SUBJECT: Customer Satisfaction Program 23B37

Certain 2023 Model Year Aviator and Explorer Vehicles equipped with 3.0L Engines
Turbo Hose Routing Inspection and Repair

FIGURE 1

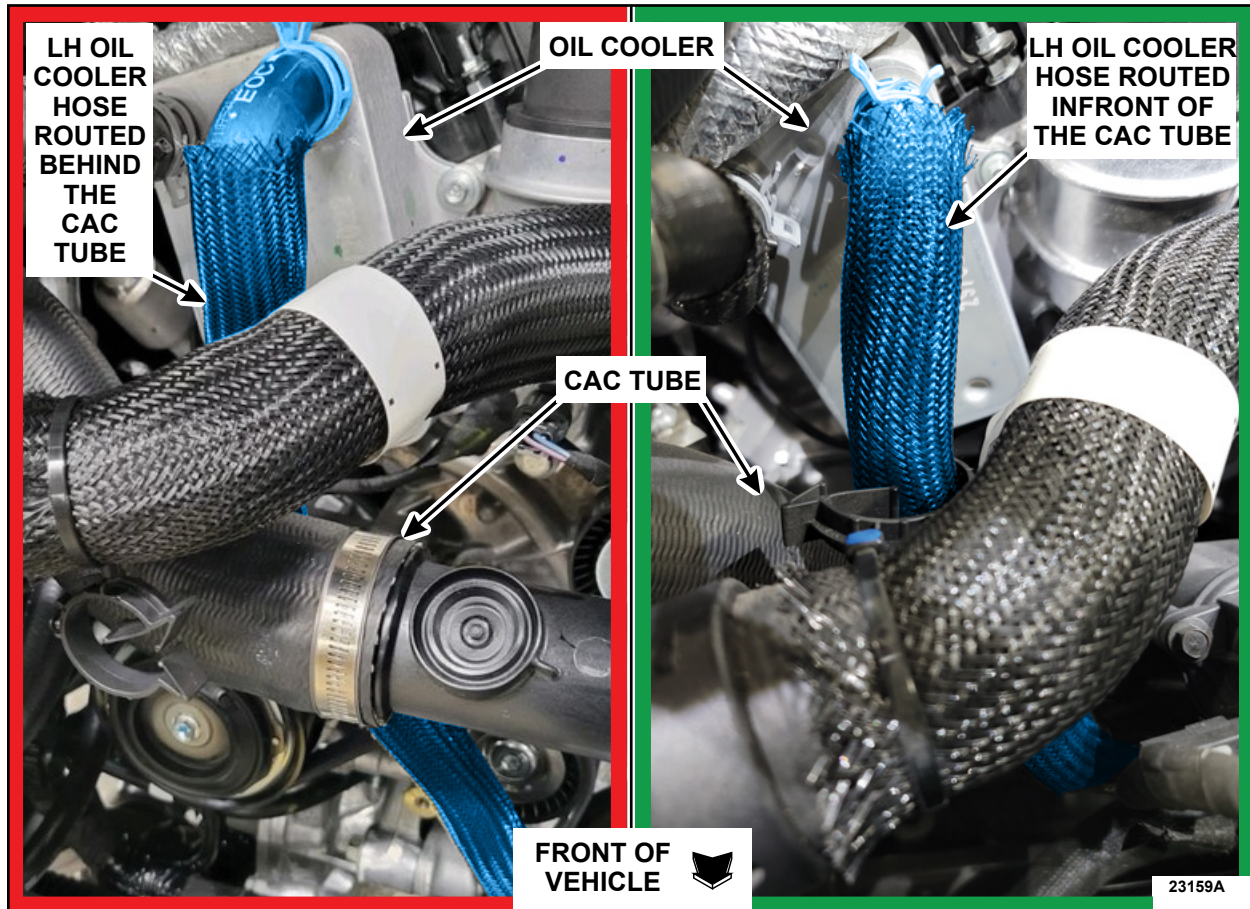
1. Open the hood of the vehicle.
2. Locate and inspect the left hand (LH) oil cooler coolant hose. See Figure 1. A LH oil cooler coolant hose that routes in front of the charge air cooler (CAC) tube passes inspection. A LH oil cooler coolant hose that routes behind the CAC tube does not pass inspection. Did the LH oil cooler coolant hose pass inspection?

FIGURE 7

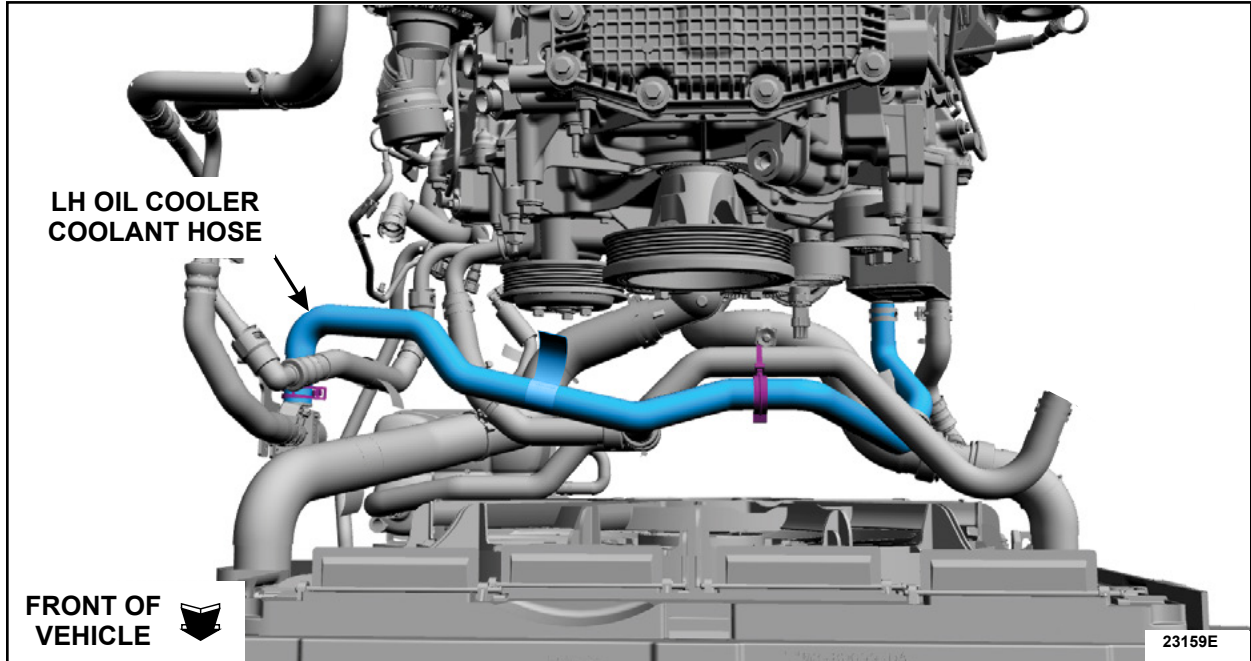
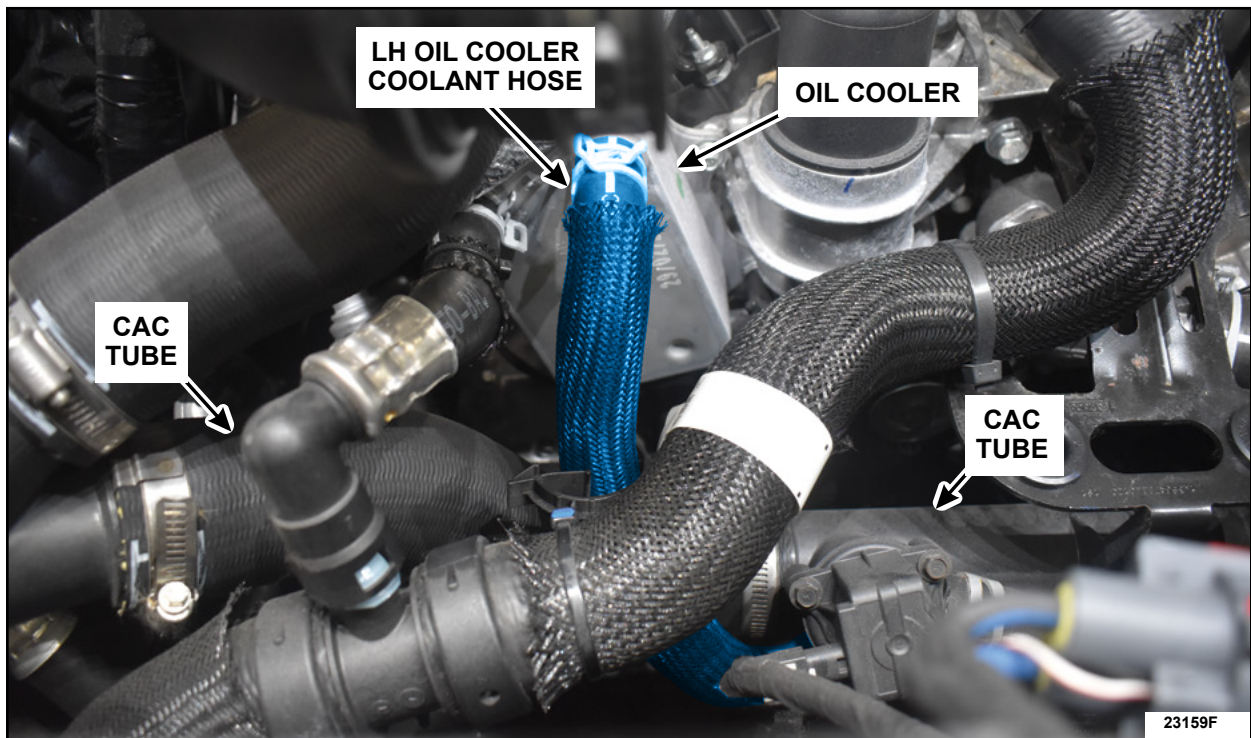
12. Replace the LH oil cooler coolant hose routing the oil cooler end of the hose over top of the CAC tube. See Figures 7 and 8.

FIGURE 9

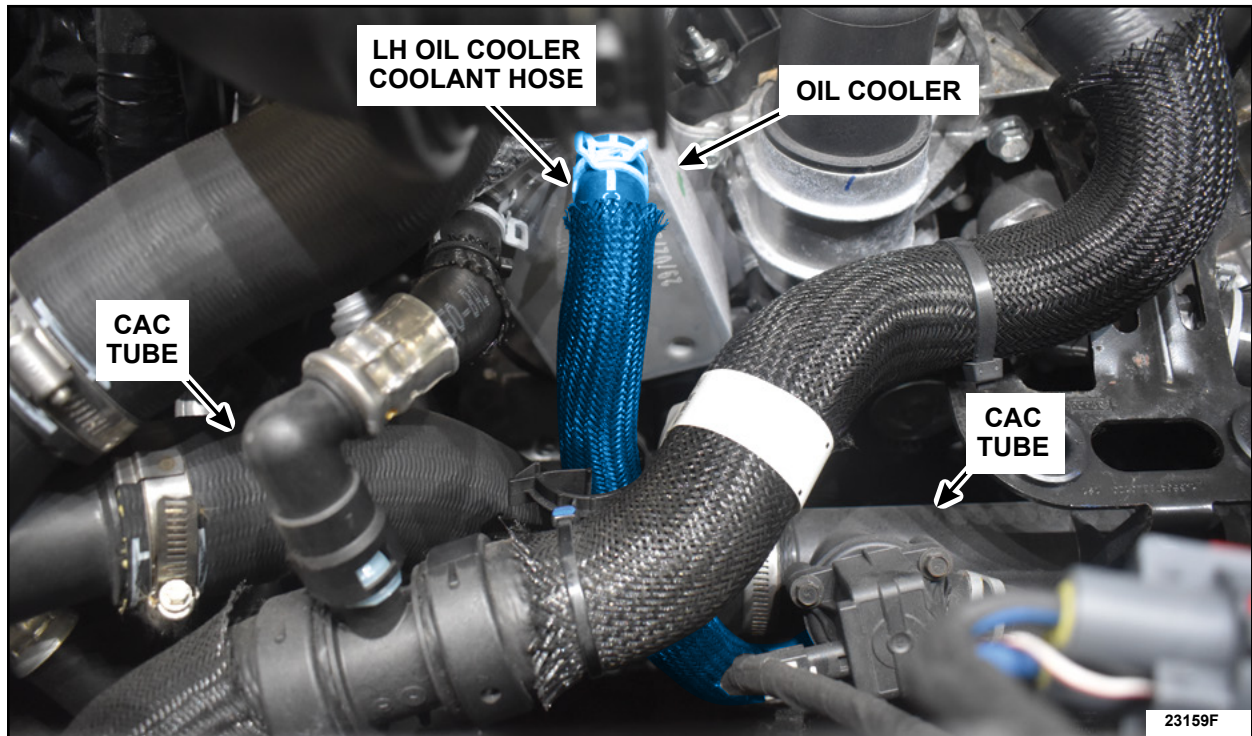
13. Install the air cleaner. Follow the WSM procedures in Section 303-12.
14. Fill and bleed the engine coolant system. Follow the WSM procedures in Section 303-03. This completes the FSA.
15. Route the LH oil cooler coolant hose over top of the CAC tube and install the hose to the oil cooler. See Figure 9.
